**SUBJECT: RECALL R11SU FMVSS 221 JOINT STRENGTH NONCOMPLIANCE-  
ADHESIVE OMITTED AT 20 GAUGE OUTSIDE SIDE  
PANEL JOINTS**

# FMVSS 221 Joint Strength Noncompliance Adhesive Omitted on 20 Gauge Outside Side Panels

**Models Affected: 2010 Model Year All American (D3) Model School Buses  
with Optional 20 Gauge Outside Side Panels**

Photo 1  
Spacing from bottom edge of window line rub rail to floor line.

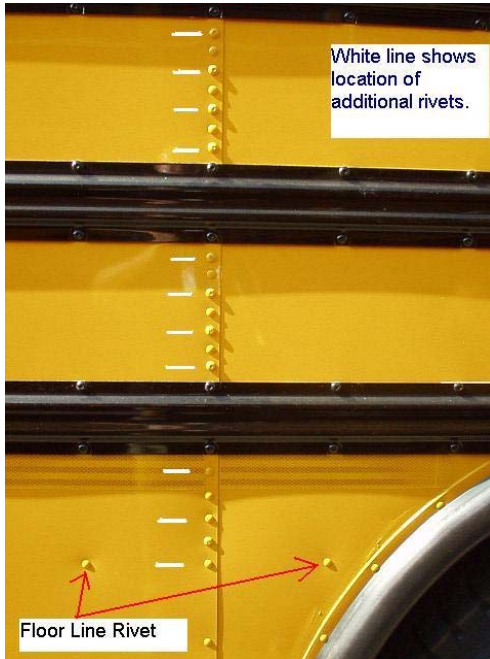
Adhesive required to meet FMVSS 221 Joint Strength requirements may have been omitted at 20 gauge outside side panel joints.

- Using a 17/64" drill bit, drill additional rivet holes at each outside side panel joint as indicated by white dash line in Photo #1 below. A drill stop set at 1/2" (0.50) must be used to prevent possible damage to wires in bow cavities. Be sure holes are evenly spaced between existing rivets and that holes stay in line with existing rivets.
